**SUBJECT: SERVICE BULLETIN S07MH CATERPILLAR C7-07
ALTERNATOR DRIVE BELT REPLACEMENT**

AFFECTED: 2008 MODEL YEAR VISION (BBCV) BUSES

Alternator Drive Belt

MODELS AFFECTED: 2008 BBCV Visions w/CAT C7-07 Engines

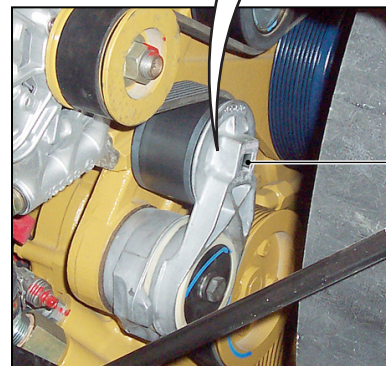
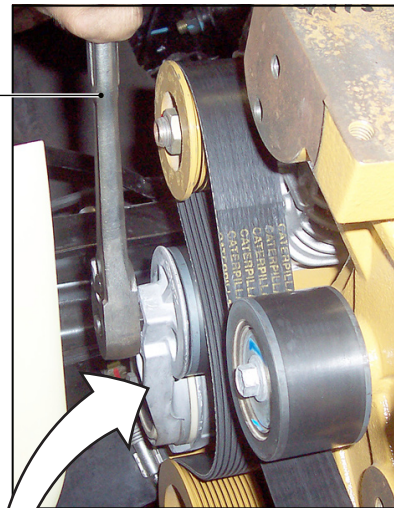
The alternator drive belt on the CAT C7-07 engine is not the correct length.

- 1** Park vehicle on a level surface, apply parking brake, turn engine off and remove ignition key.
- 2** Locate the alternator drive belt idler pulley. Using a 1/2 inch drive pull handle, insert it into the square socket of the idler pulley arm. Apply force upward in a counter-clockwise direction to release tension from the belt and slide the belt off the pulley. Slowly release the applied pressure from lower idler pulley.

- 5** Insert the 1/2 inch drive pull handle into the square socket of the idler pulley arm. Apply force upward in a counter-clockwise direction and slip the belt into place at the idler pulley. Ensure the belt is correctly aligned on all pulleys before releasing pressure from the idler pulley.

Replace the alternator drive belt with a new drive belt provided (Blue Bird P/N 0122527).

- 3** Working the belt around the other engine components in a circular motion, remove the belt and discard.
- 4** Install the new belt (Blue Bird P/N 0122527), slipping it over the other engine components and onto their pulleys.
